BEFORE THE OTAGO REGIONAL COUNCIL

In the matter of application **RM19.151** by **BSTGT Limited and Trustees of the A P McQuilkin Family Trust** for a permit to take and use water

STATEMENT OF EVIDENCE OF HILARY KAY LOUGH

25 MAY 2021

Figure 1: Figure 4, reproduced from fish survey report (Hickey, 2020)

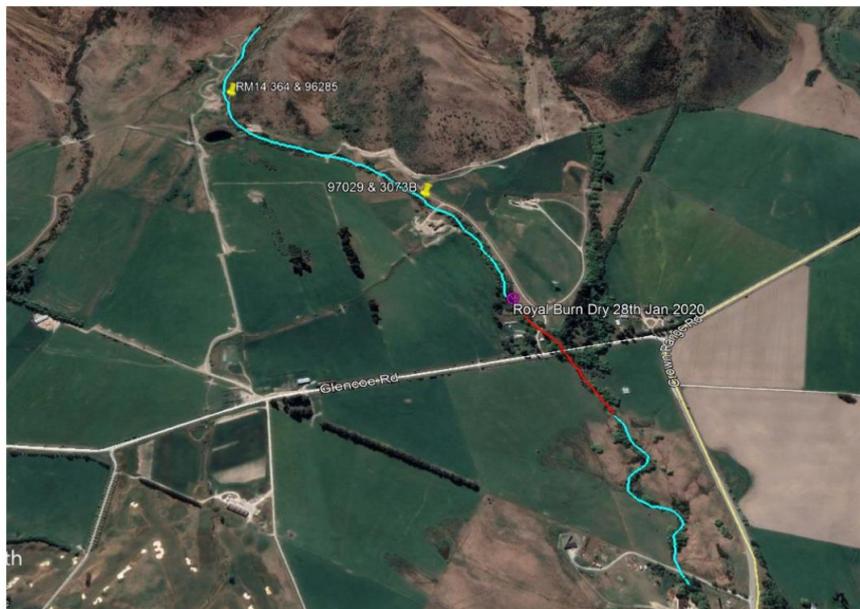
19. Losses to groundwater from the Royal Burn much greater than those observed above were observed during a fish survey. Matt Hickey of Water Resource Management Ltd undertook a fish survey on 28 January 2020. Mr Hickey states in the report on that work that: "*Downstream of take 97029 and 3073B the North Branch of the Royal Burn went dry despite two thirds of the flow passing the intake, indicating that the lower section of the Royal Burn North Branch is naturally intermittent*". Figure 4 from Mr Hickey's report showing the observed dry reach is reproduced below.

30. Although the surface waterways flowing across the terrace are likely to generally lose to groundwater, the terrace aquifer materials likely thin and pinch out towards the terrace edge where the surface waterways have locally incised the land and it is possible that the groundwater system then discharges back to the surface waterways in the vicinity/just above of the terrace edge. In terms of hydraulics, the basement rock boundary is likely to be of relatively low permeability and may force groundwater to emerge back at the land surface where the extent of the old alluvium ends (towards the terrace edge). This pattern of a gain in flow towards the terrace edge was supported by the 22 February 2021 NIWA gaugings.
